# Notice

### Information request

### Further information is required to assess an application for a site-specific environmental authority

The application reference number is: A-EA-NEW-100521948

Comet Ridge  
Mahalo North CSG Project  
Environmental Authority  
Supporting Information Report for a Petroleum Lease  
Figure 14  
Mapped environmentally sensitive areas

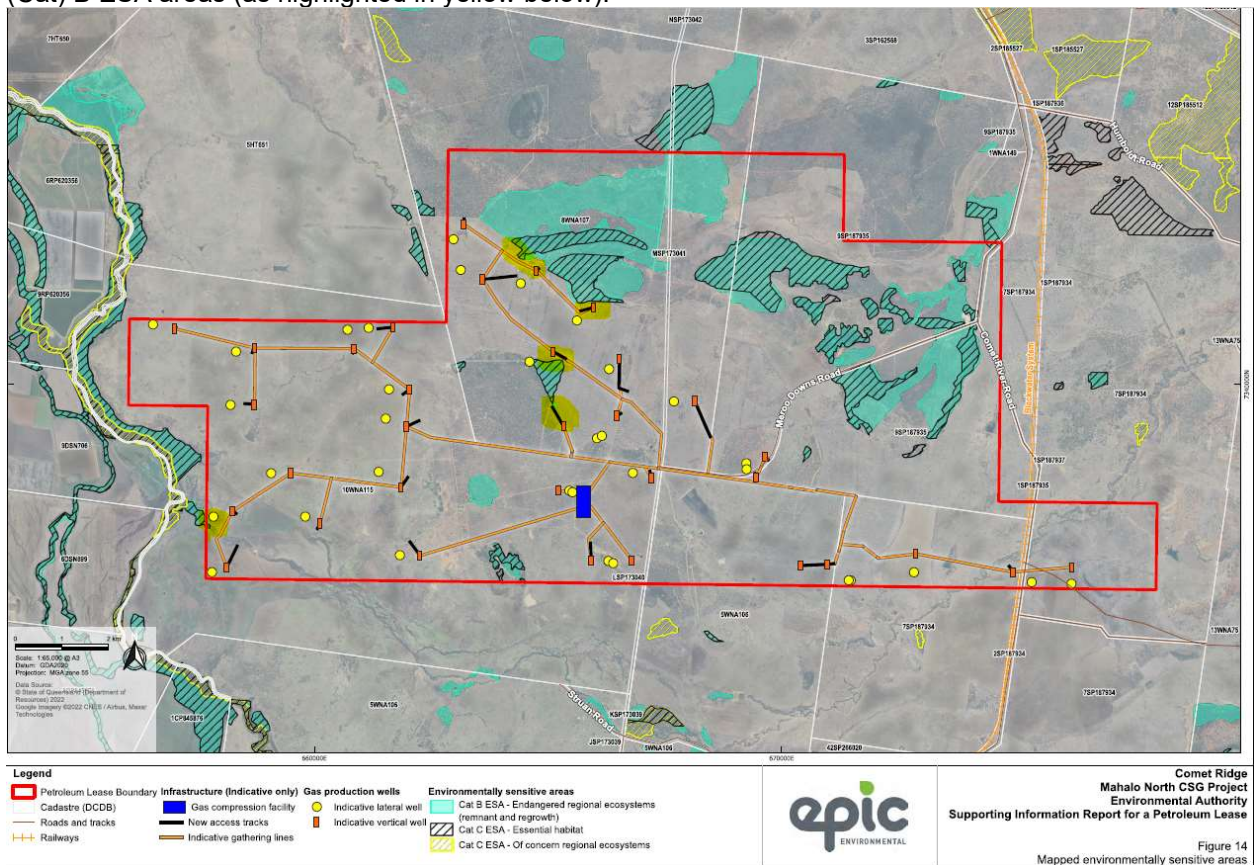
<p>A protected area – nature refuge</p>				
	<p><b>HIGHLY PROTECTED ZONES OF STATE MARINE PARKS</b></p>				
	<p>A highly protected area of a relevant Queensland marine park.</p>				
	<p><b>FISH HABITAT AREAS</b></p>				
	<p>A declared fish habitat area – insert reference</p>				
	<p><b>WATERWAY PROVIDING FOR FISH PASSAGE</b></p>				
	<p>Any part of a waterway (not in an urban area) providing for passage of fish – insert reference</p>				
	<p><b>MARINE PLANTS</b></p>				
	<p>Marine plant (not in an urban area) – insert reference</p>				
	<p><b>LEGALLY SECURED OFFSET AREA</b></p>				
	<p>Legally secured offset area – insert reference</p>				
10	<p><u>Issue</u></p> <p>The application material states that the project will not disturb Environmentally Sensitive Areas (ESAs) or their protection zones. However, Figure 14 ‘mapped environmentally sensitive areas’ of the ‘Supporting</p>

Information Report' depicts some indicative vertical wells and access tracks adjacent mapped Category (Cat) B ESA areas (as highlighted in yellow below).

1. Please confirm the buffer distances between the mapped Cat B ESA on Figure 14 and the adjacent proposed disturbance.
2. Should the proposed disturbance impact the primary or secondary protection zone, please quantify the extent to which disturbance impacts within ESAs and their associated protection zones using the below table. These impacts should be listed against each protection zone trigger (i.e. Category B, Category C, and for each listing of 'Essential Habitat' or 'Of Concern', etc.). If certainty cannot be provided, justification should be provided that outlines appropriate risk management strategies to avoid impacts.
